Final Focused Feasibility Study Report
Ground Water Remediation

Shieldalloy Metallurgical Corporation
Newfield, New Jersey

Prepared by:
TRC Environmental Corporation

April 1993
Revision 1: June 1993
Revision 2: February 1994

LOCATIONS OF GEOLOGIC CROSS-SECTIONS A, B, AND C

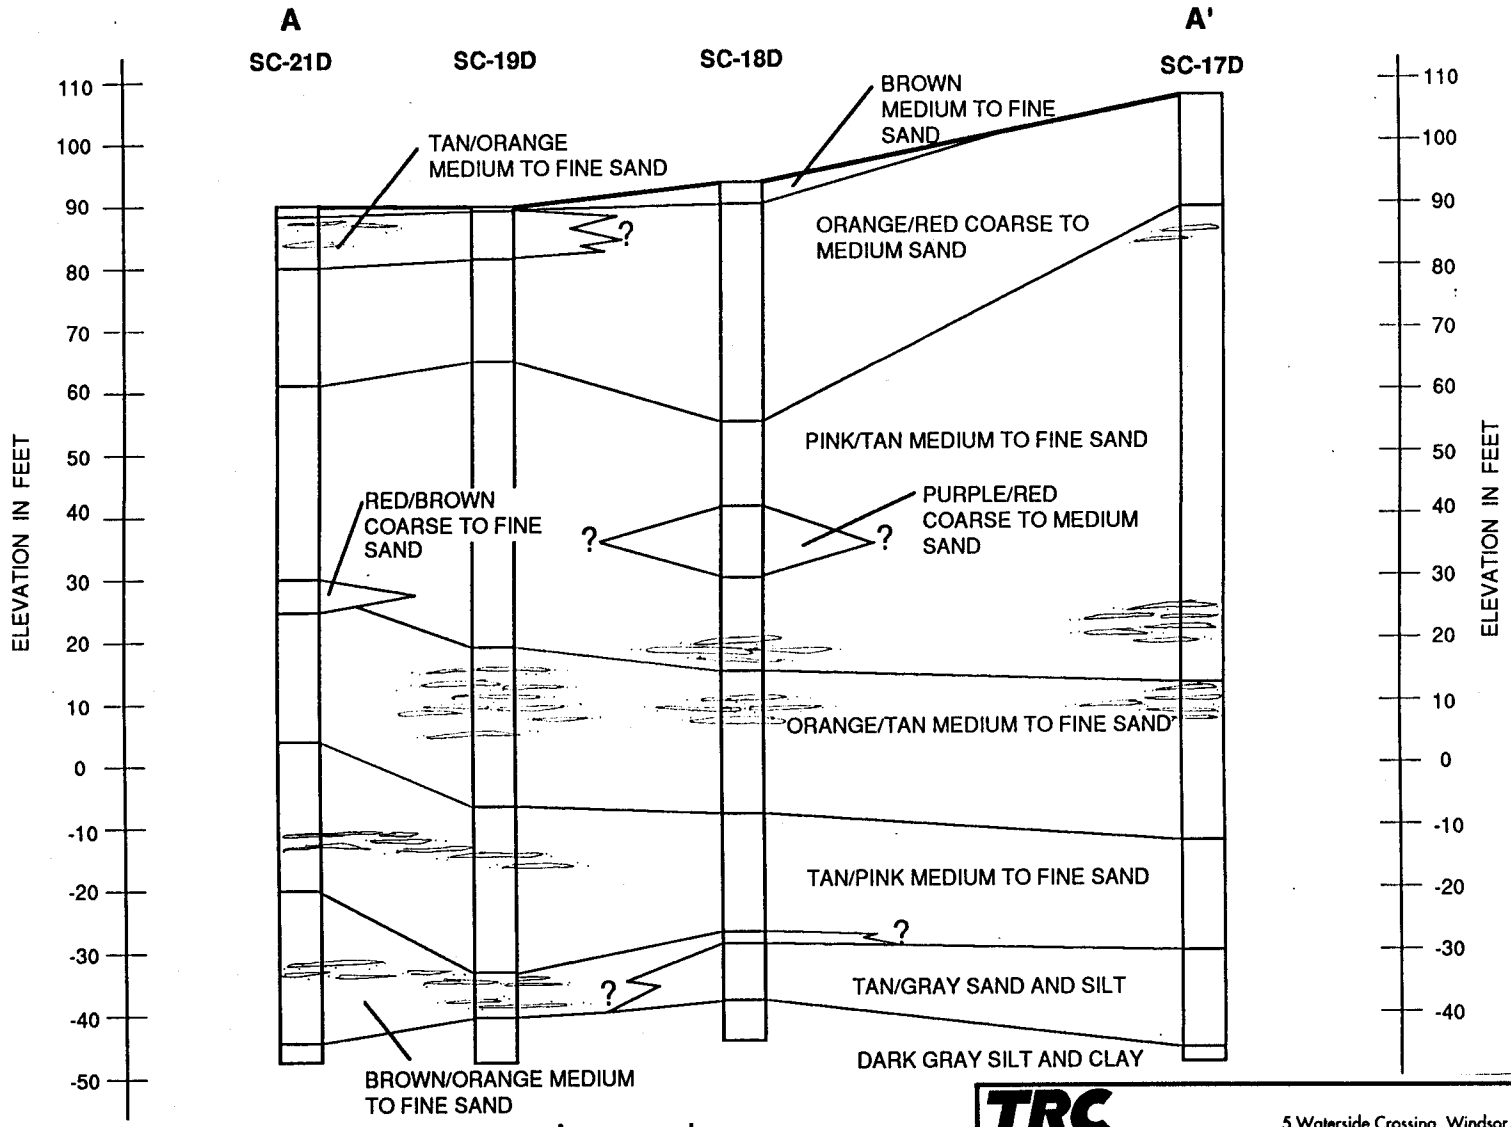
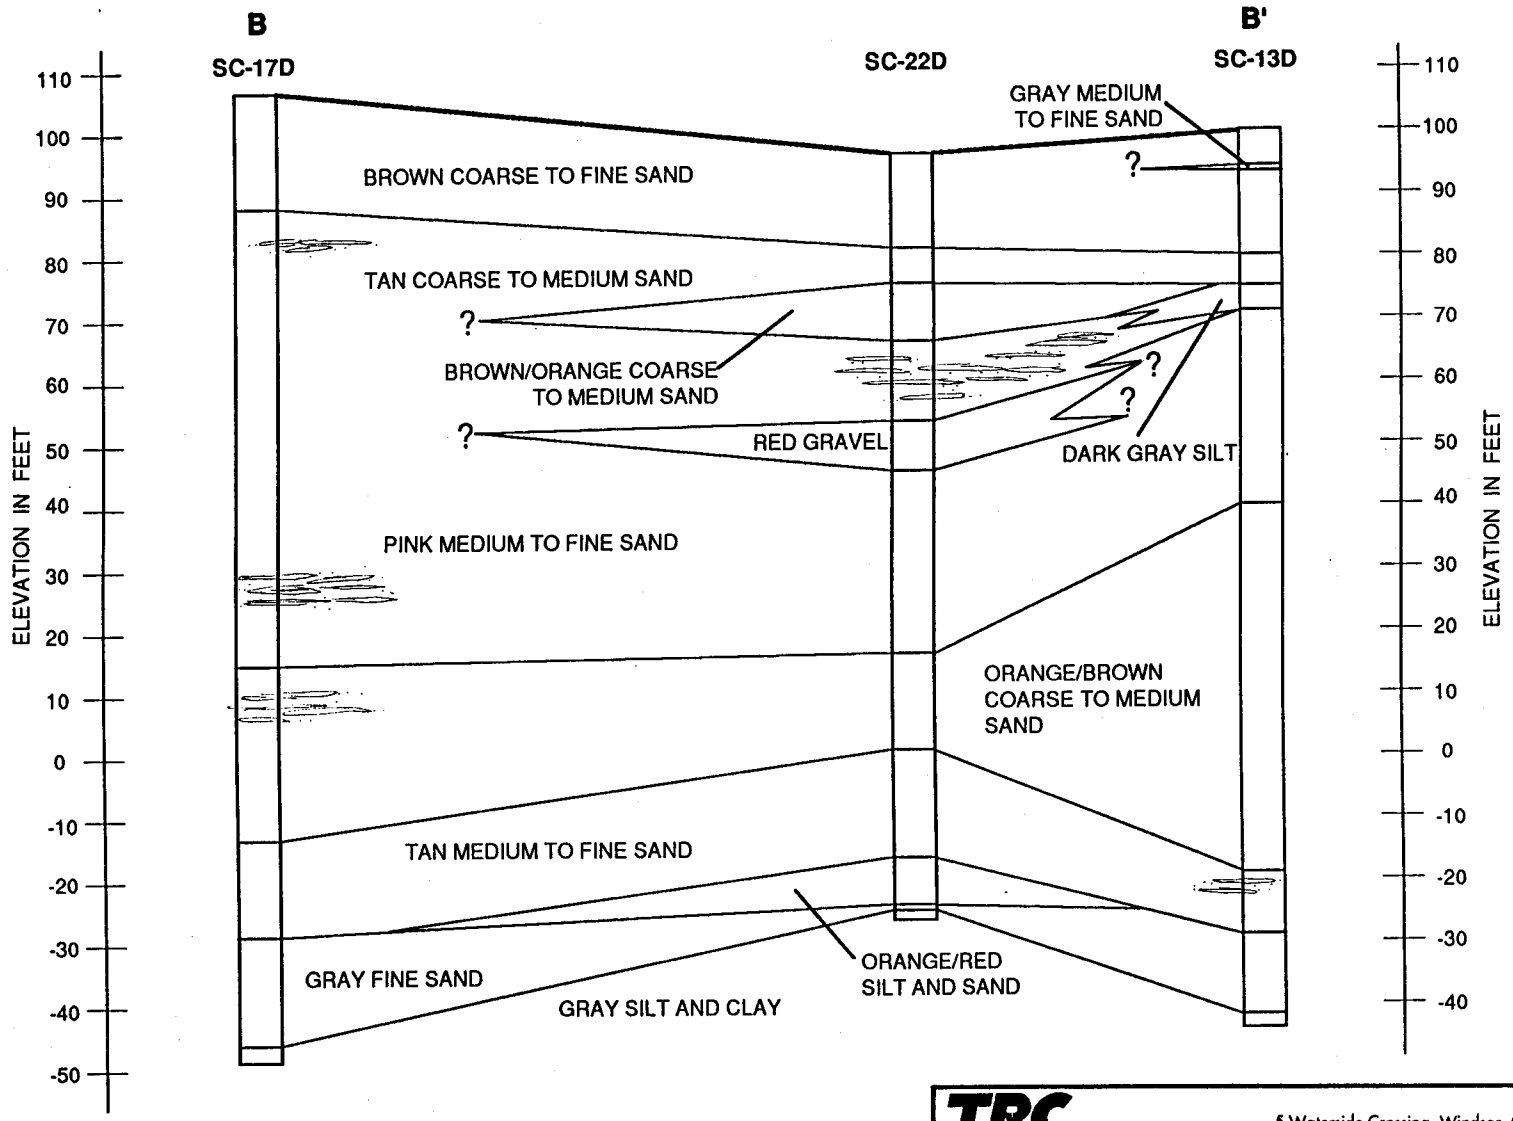
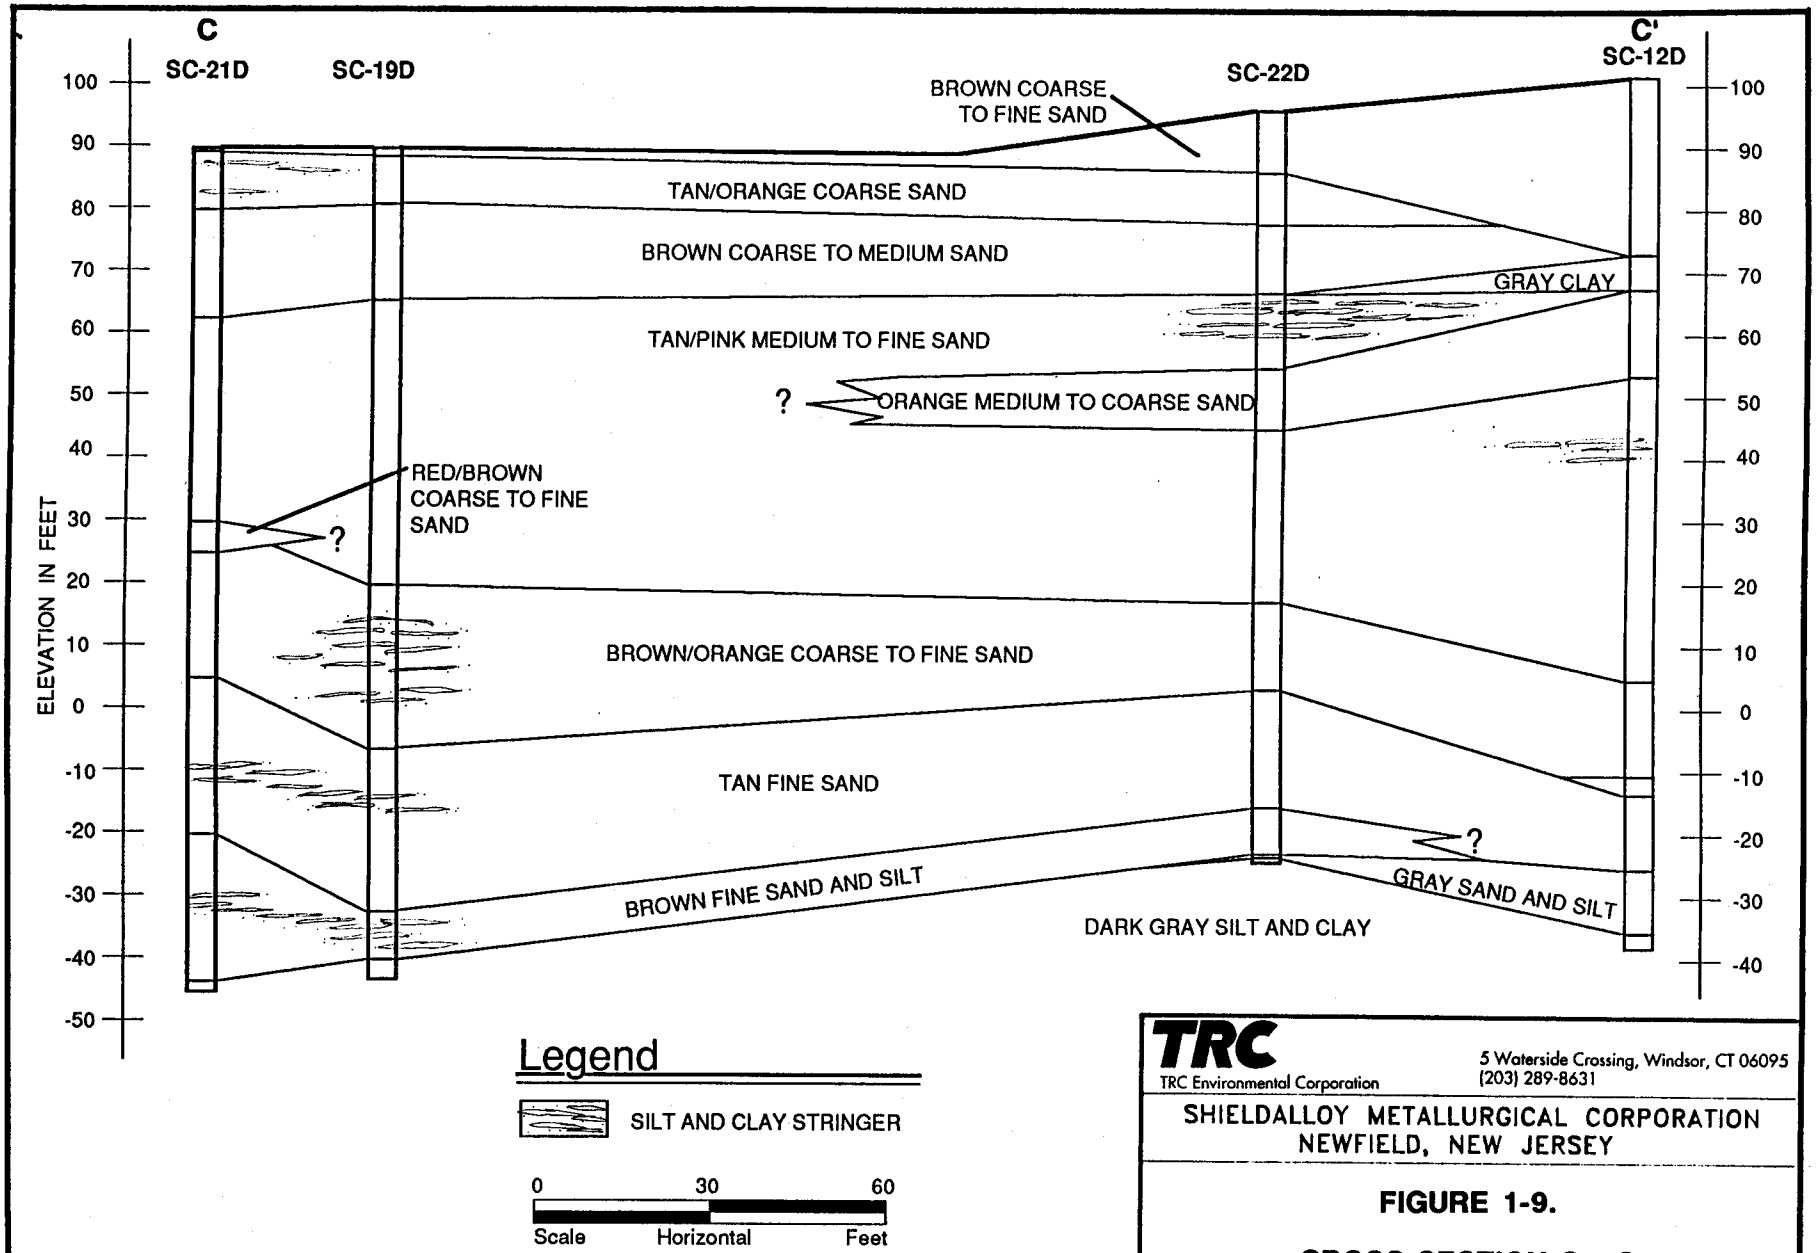
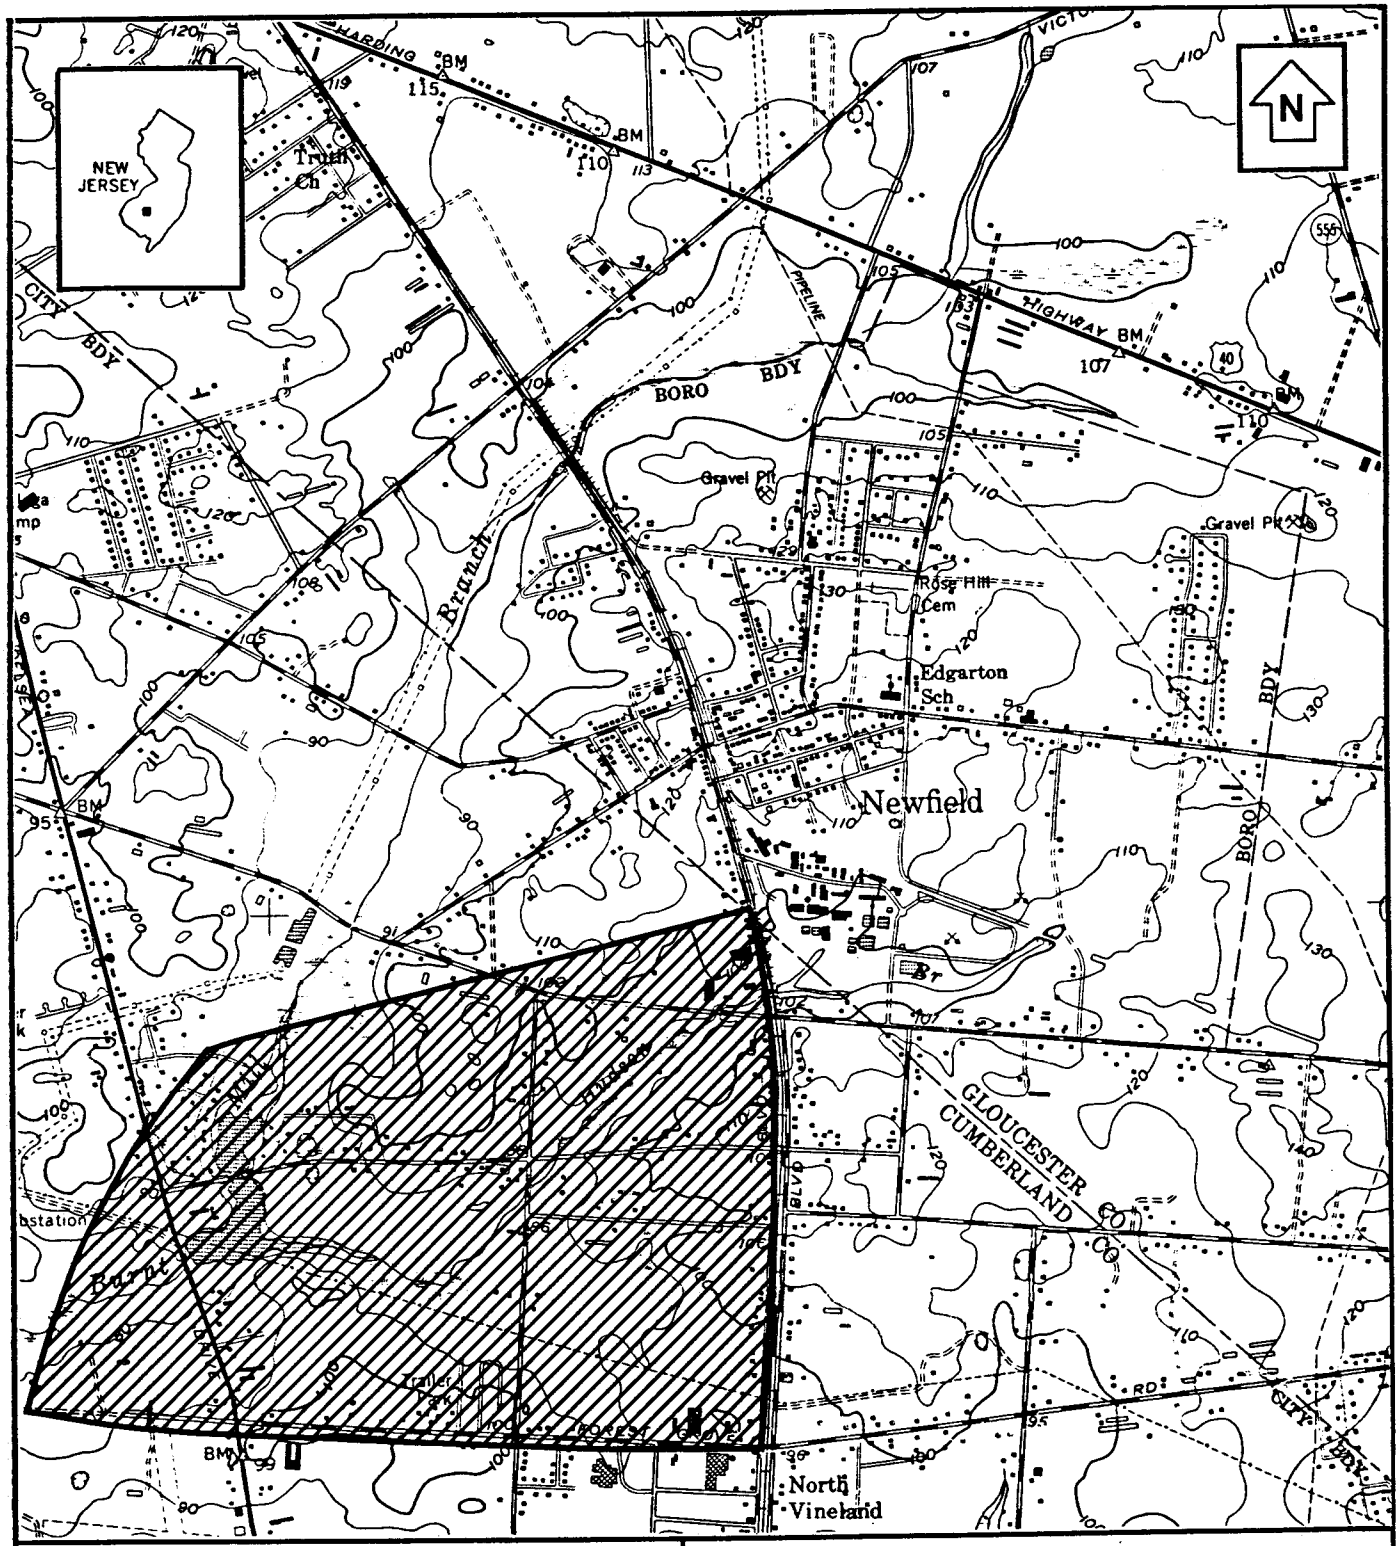
12. <u>Pages 1-10 thru 1-12, Section 1.5.2 - Geology</u>
Three generalized cross-sections are presented (Figures 1-6 through 1-9), along generally parallel tracks from the eastern portion of the site, southwest, parallel to the Hudson Branch. The cross-sections are fairly typical of the Cohansey Sand, with interbedded sands, silts and clays. In general, they show fine sand and silt (10 to 20 feet) at the bottom of the section, overlain by progressively coarser units. The middle of the section is shown as interbedded units of coarse

FIGURE 3-4.
TCE CONCENTRATIONS (PPB)
DEEP WELLS
APRIL, 1991

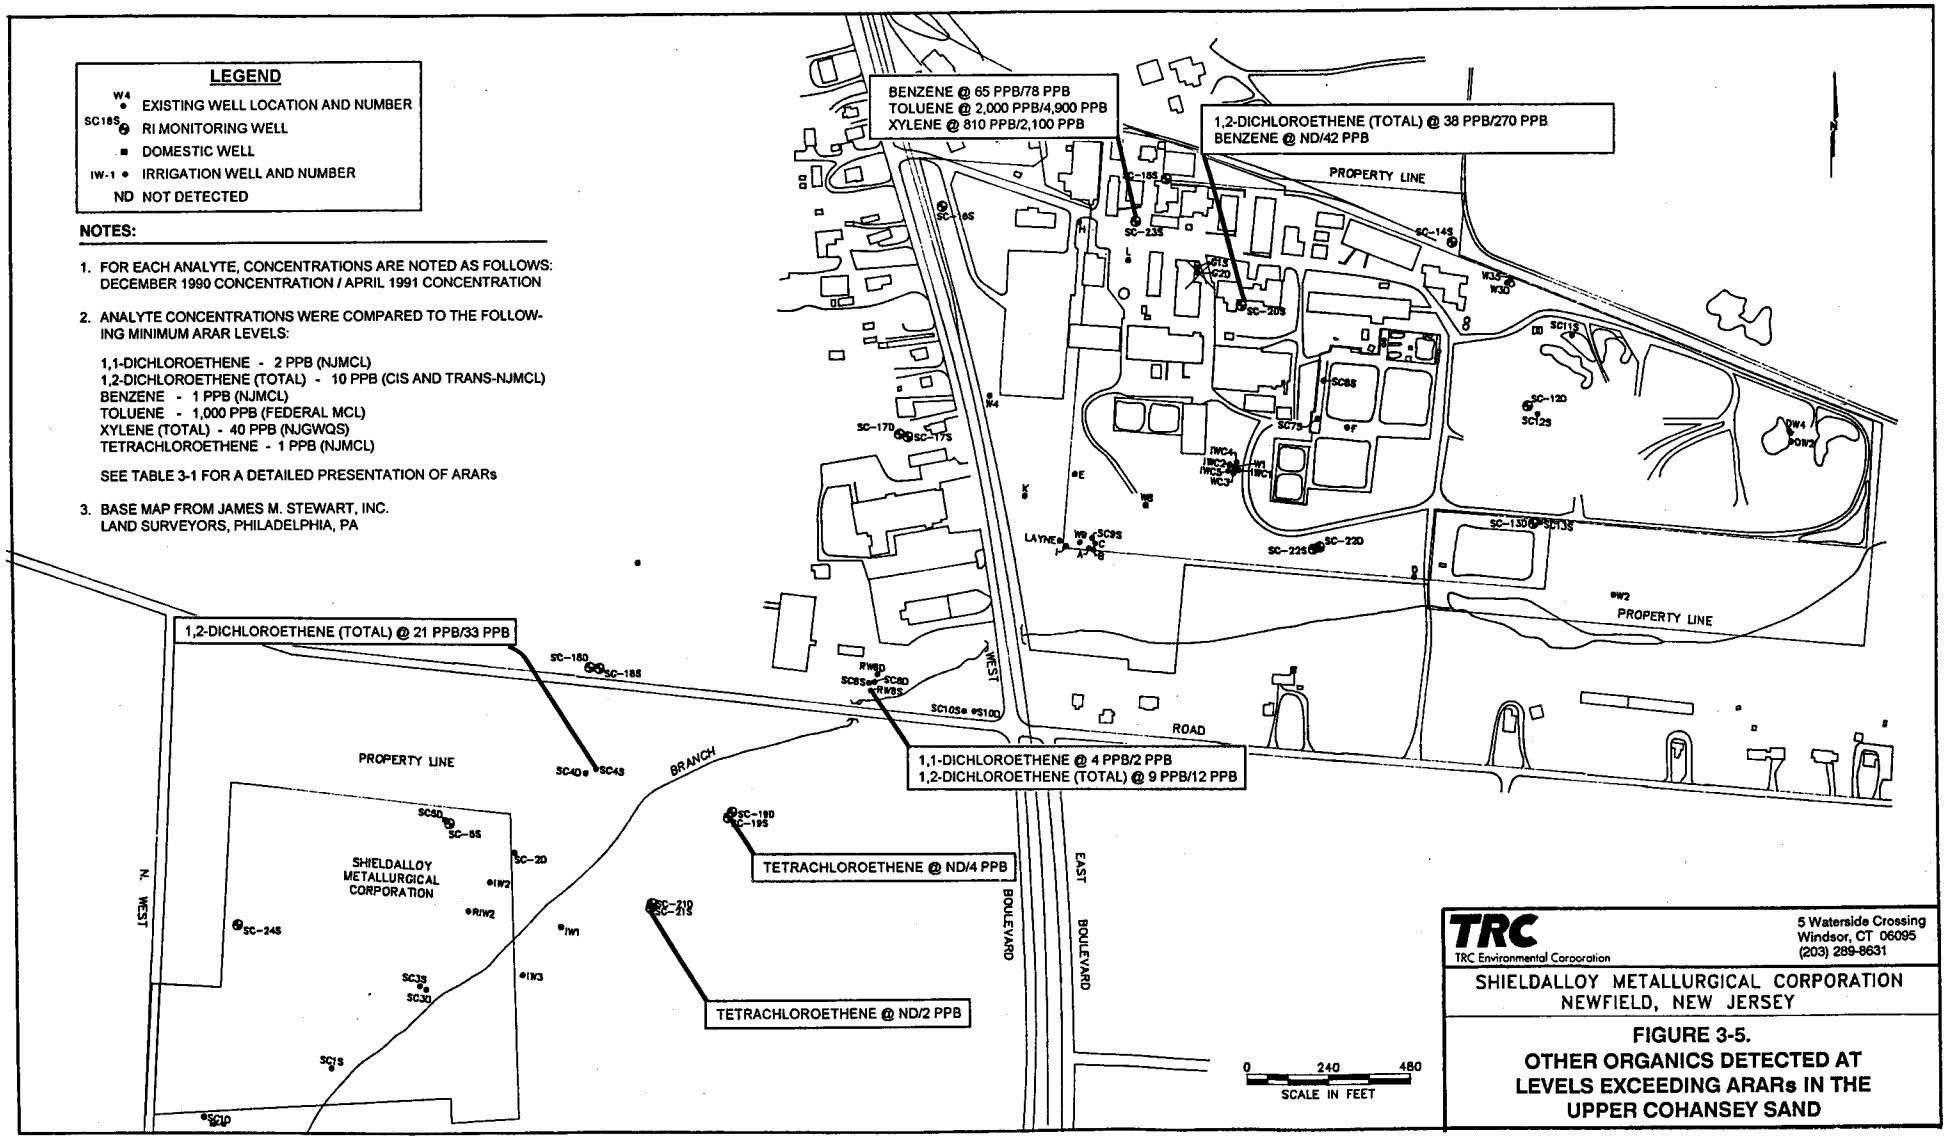
The danger of putting too much emphasis on isopleth maps is that it is difficult to keep in mind that they can only show concentrations where wells have been sampled. For example, the deep TCE contours (Figures 3-4 and 3-5) show a 1 ppb "boundary" on the south side of the plume. Now, with the discovery of 12 ppb TCE in SC22D, it is obvious that the previous boundary was present only because data points were lacking in critical areas.

Response: *An initial review of the TCE isopleth maps may seem to indicate an offset in the deep TCE plume to the south from the shallow plume location, however, this offset may be partially due to the lack of deep ground water data in the plant area (see the response to general comment #20). In December 1990, well G2D, the only deep well in the plant area, exhibited no TCE. Well G2D was not sampled in April 1991. Therefore, while TCE contamination in the deep wells could potentially extend to the northeast of the area shown in Figures 3-3 and 3-4, the lack of data in this area resulted in the interpretation of isopleths as presented in these figures.*
